**PLANNED UNIT DEVELOPMENT
& SUBDIVISION STAFF REPORT****November 16, 2017**

<u>DEVELOPMENT NAME</u>	Austill Estate Division Subdivision
<u>SUBDIVISION NAME</u>	Austill Estate Division Subdivision
<u>LOCATION</u>	114 Austill Avenue (North terminus of Austill Avenue, extending to the South side of Austill Place, 140'± East of Carmel Drive East).
<u>CITY COUNCIL DISTRICT</u>	District 7
<u>AREA OF PROPERTY</u>	6 Lots / 3.7± Acres
<u>CONTEMPLATED USE</u>	Planned Unit Development Approval to allow a family division subdivision with irregularly-shaped lots and reduced public street frontage, and Subdivision approval to create six legal lots of record from an existing metes-and-bounds parcel.
<u>TIME SCHEDULE FOR DEVELOPMENT</u>	None given.
<u>ENGINEERING COMMENTS</u>

SITE PLAN

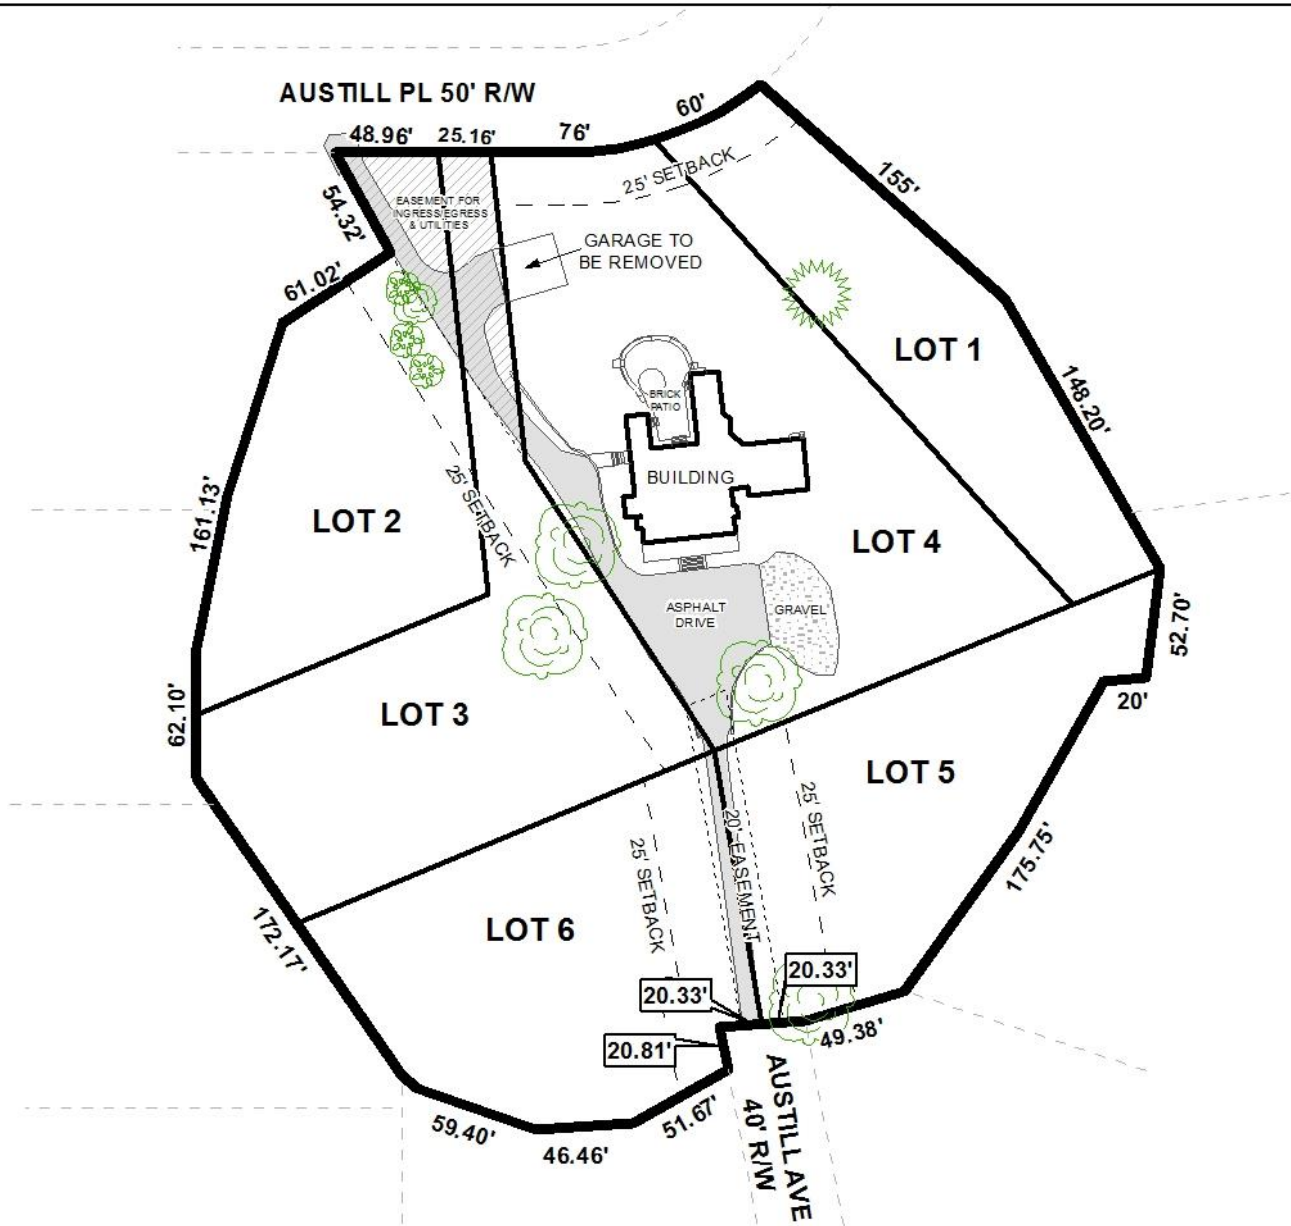
- A. Provide all of the required information on the SUBDIVISION PLAT (i.e. signature blocks, signatures, certification statements, written legal description, required notes, legend, scale, bearings and distances) that is required by the current Alabama State Board of Licensure for Professional Engineers and Land Surveyors.
- B. REMOVE THE MOBILE COUNTY ENGINEERING DEPARTMENT NOTE. THIS PROPOSED SUBDIVISION IS LOCATED WITHIN THE CITY LIMITS. THE COUNTY ENGINEER NO LONGER SIGNS PLATS WITHIN THE MUNICIPAL LIMITS OF THE CITY OF MOBILE.
- C. Show and label the existing parcels.
- D. Provide adequate turn-around (public ROW) at the north end of Austill Ave.
- E. Add "COMMISSION" to the MOBILE CITY PLANNING signature block.
- F. Show and label each and every Right-Of-Way and easement. Check the east side of LOT 1.

- G. Provide and label the monument set or found at each subdivision corner.
- H. Provide the Surveyor's, Owner's (notarized), Planning Commission, and Traffic Engineering signatures.

- I. Add a note to the SUBDIVISION PLAT stating that as shown on the 1984 aerial photo (FLIGHT 22 - #79) LOTS 1-6 will have to share the historical credit of existing (1984) impervious area towards stormwater detention requirement per Mobile City Code, Chapter 17, Storm Water Management and Flood Control). Coordinate with City Engineering Department staff to establish the exact amount that each Lot will receive prior to the submittal of the Final Plat from review and signatures.

As per the Engineering comments, an adequate turn-around (public ROW) must be provided at the north end of Austill Avenue. As this may alter the configuration of Lots 5 and 6, these applications should be heldover to the meeting of December 21st to allow the applicant to coordinate with Engineering on the required dedication to provide the right-of-way for the turn-around. It is also advised that the Fire Department should be consulted as to what size turn-around is required to meet the current Fire Code standards.

Subdivision: Based upon the preceding, this application is recommended for holdover to the meeting of December 21st to allow the applicant to coordinate with Engineering on the required dedication to provide adequate right-of-way for a turn-around at the North end of Austill Avenue. It is also recommended that the Fire Department should be consulted as to what size turn-around is required to meet the current Fire Code standards.

Planned Unit Development: Based upon the preceding, this application is recommended for holdover to the meeting of December 21st to allow the applicant to coordinate with Engineering on the required dedication to provide adequate right-of-way for a turn-around at the North end of Austill Avenue. It is also recommended that the Fire Department should be consulted as to what size turn-around is required to meet the current Fire Code standards.
